Offshore coordination project

Stakeholder feedback 29 June – 3 July

July 2020

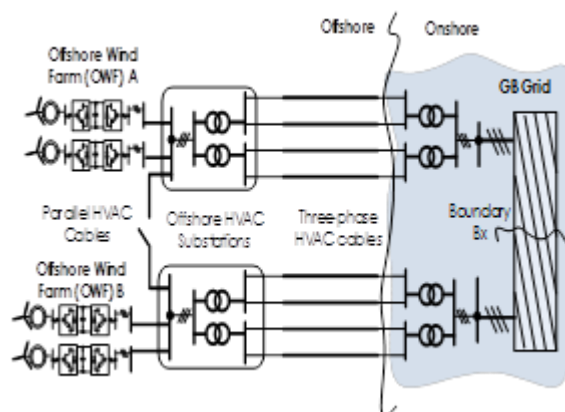
2. Are you not considering conventional interconnected AC offshore? Some less developed sea areas, nearer to shore could be economic as conventional AC.

In response to stakeholder feedback we have created conceptual design **Topology T1A (Integrated HVAC)**, shown in the figure below, will be used to assess the maximum scale of offshore wind farms (in terms of size and distance from shore) that can be connected using today's HVAC technology.

Our assessment will consider for HVAC technology options:

- flexibility to gather power from multiple wind farms, distribute power across parallel routes, and connect together multiple windfarm projects;
- limits in terms of the size of power that can be transported and the circuit length;
- additional equipment required for improved voltage regulation, to facilitate transmission over distances up to 200km, to ensure harmonics do not exceed required limits and for operational control purposes, and
- opportunities to extend or integrate design solutions including in combination with other technology options.
